Technical Review Report

## 2018 Work Scope for Appendix No. 6 Findings of the Technical Review Team

**Water Resources Agency  
Ministry of Economic Affairs, Taiwan**

A technical review of specific issues related to Naio-Zuei-Tan Artificial Dam, Sun Moon Lake, Hushan Reservoir, Renyitan Spillway, Nan-Hua Submerged Weir, Tseng-wen-Nan-Hua Interconnecting Pipeline, JhongJhung Artificial Dam, as well as a 1-day training course focused on Dam Safety and Instrumentation and Monitoring was performed by the undersigned members of the Bureau of Reclamation Technical Review Team through Appendix 6 cooperation and at the request of the Water Resources Agency, Ministry of Economic Affairs in Taiwan. Our findings and conclusions are outlined in the report following.

Figure 17. – Proposed location of submerged weir and desilting tunnel at Nanhua Reservoir.

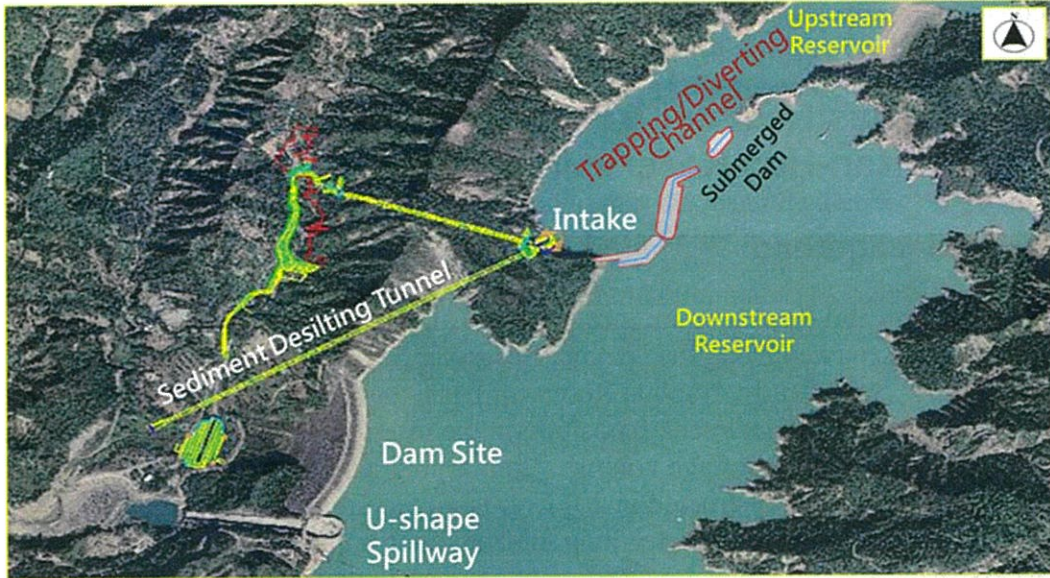
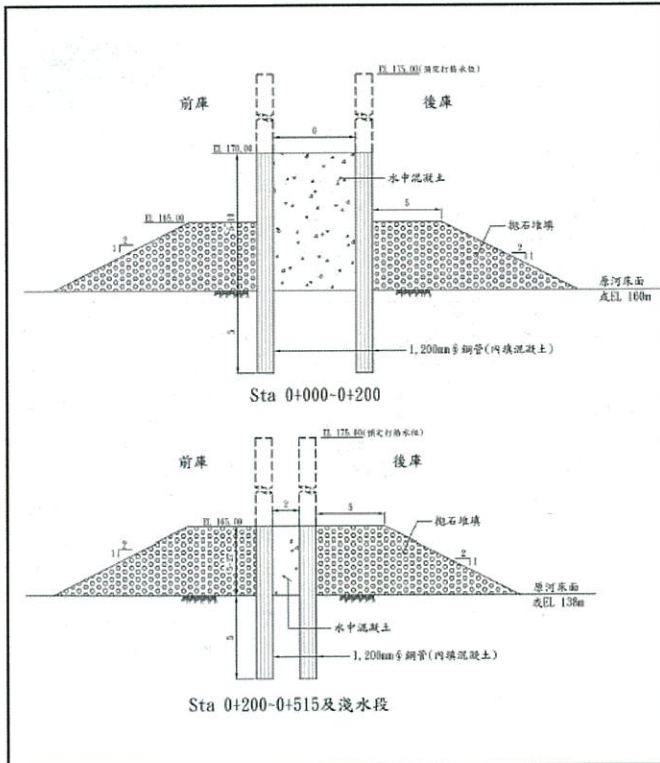
- The proposed submerged weir and sluicing tunnel portal are located at the toe of a bedrock dip slope that has unfavorable bedding orientations and historic landslides. See Photos 5 and 6. The long-term stability of this slope as it affects the project is a concern. Monitoring has indicated horizontal movement of the bedrock of approximately 0.5 cm per year.

- Concern that coarser material (sand, gravel, cobbles, and boulders (up to 1 meter diameter)) will damage the concrete lining of the tunnel as velocities approach 30 m/sec.
- In the event the sluicing tunnel is overwhelmed during torrential rain, there is concern that high-velocity flows could erode the submerged dam. However, the concrete core (2 meters thick) would likely remain intact.

- Submerged Weir and Portal –
  - Continue monitoring of survey points on the dip slope above the portal. Also consider use of newer technologies such as terrestrial lidar, radar, INSAR, photogrammetry to obtain baseline topographic survey so that detailed measurements of displacement can be monitored for comparison with future surveys.

- Perform a detailed slope stability analysis using all available data and the existing slope geometry, then perform a sensitivity analysis to assess the potential effects of erosion at the base of the slope.

- Concrete lining damage - If not already considered, the compressive strength of the concrete lining could be further increased by adding silica fume to the mix design. Initiating and maintaining periodic inspections will be important. If damage does occur to the concrete lining, then concrete repairs can be made in a timely manner.

- Concrete lining damage - With time, it may be found that it is more economical to install a steel liner than to continue to make reoccurring costly concrete repairs. Dam safety and/or life loss do not appear to be a concern. This is because damage to the lining will be found and repaired in a timely manner, due to periodic inspections.

- Consider constructing a physical model to assess how the submerged weir will perform during such a flood event
- Regarding how to improve the likelihood that the rock-fill materials associated with the submerged weir will stay in place, the following could be considered.

- Flatter slopes
  - Use of larger sized riprap
  - Grouted riprap
  - Other armoring for the riprap, such as a reinforced concrete overlay.
- Consider use of a physical model and/or consultation with sedimentation experts (Appendix 8) regarding an alternative to the submerged weir or trapping/diversion channel.

Figure 19. - Proposed Design for Trapping/Diverting Channel

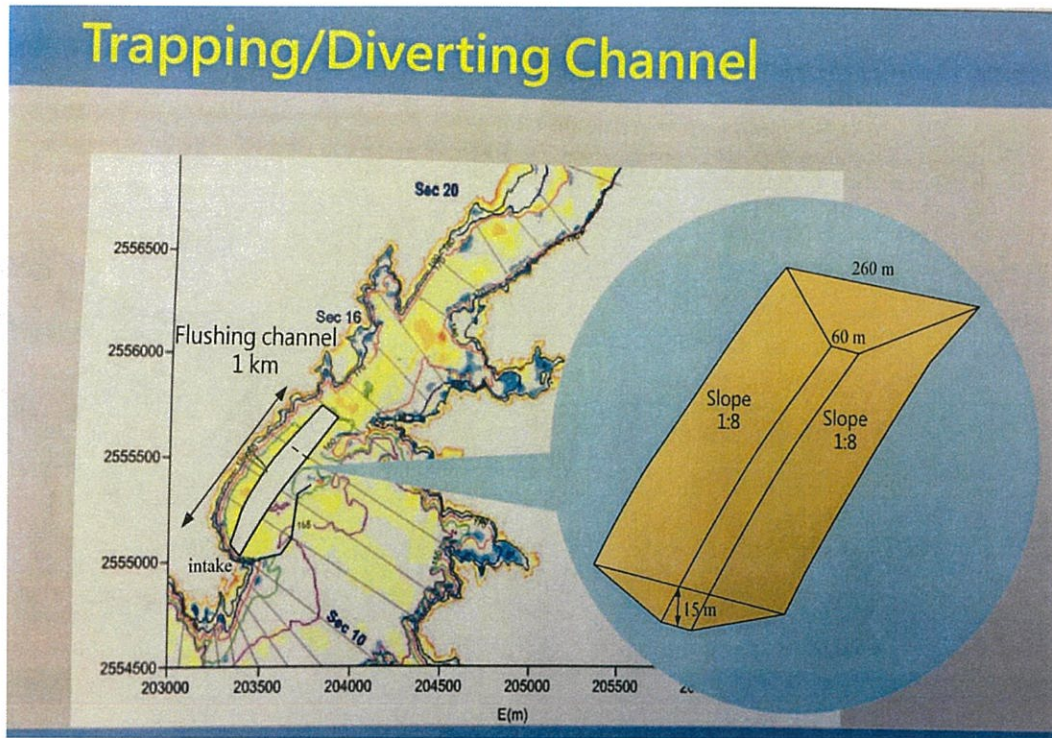
- Figure 19 shows a design for a trapezoidal channel excavated into the upper reservoir basin as an alternative to the submerged weir to divert sediment into the desilting tunnel. There is concern about the effectiveness of this solution.

Figure 23. Tunnel Alignment and Profile

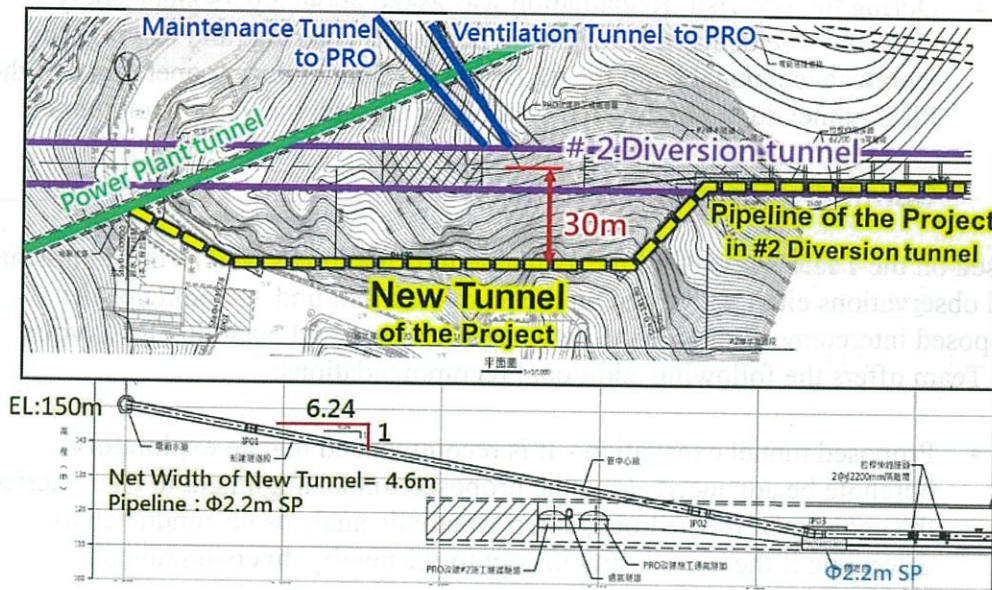
A portion of the pipeline will be installed in existing Tsengwen Diversion Tunnel No. 2 and will occupy part of the cross-sectional area of the tunnel as shown in Figure 23. WRA is interested in Reclamation's opinion regarding whether the ventilation required for Permanent River Outlet (PRO) will be affected.

- There is concern that proposed new tunnel excavation (shown in yellow will impact the integrity of the existing diversion tunnels. Analysis has been conducted using the simplified strength model of Hoek and Brown. This analysis does not address the site specific sandstone and shale foundation materials or associated discontinuities (joint sets, shear zones, faults etc.).

- Regarding ventilation requirements for the PRO, the decrease in cross-sectional area in the #2 Diversion Tunnel (due to construction of the pipeline and its support) is about 19 percent. There is concern that a reduced cross sectional area could have adverse effect on ventilation requirements for the PRO.

- During the site visit, Reclamation was asked about a personnel safety concern. The concern is regarding personnel entering (and leaving) the maintenance tunnel from the #2 Diversion Tunnel during operations of the PRO tunnel due to high velocity air flow through the ventilation tunnel.

- Proposed tunnel excavation - It is recommended that an exploratory borehole be advanced along the proposed tunnel alignment to characterize the geology of the bedrock, and a kinematic analysis be conducted to determine if there are is any impact to the nearby diversion tunnels (removable blocks, etc.)
- Water Hammer - The gate can always be closed at an even slower rate to further reduce concerns.

- Ventilation - If not done already, air-demand calculations can be completed to determine if the PRO can operate as designed, and if air velocities will be excessive in the system.
- Personnel Safety - A concrete wall could be constructed within the #2 Diversion Tunnel to separate the high velocity air flow from personnel entering (or leaving) the maintenance tunnel. The wall would be constructed parallel to air / personnel traffic, be approximately be approximately 3 meters in height, 0.3 meters thick, and an appropriate length. Personnel could then safely, and comfortably, access the maintenance tunnel during operation of the PRO tunnel.
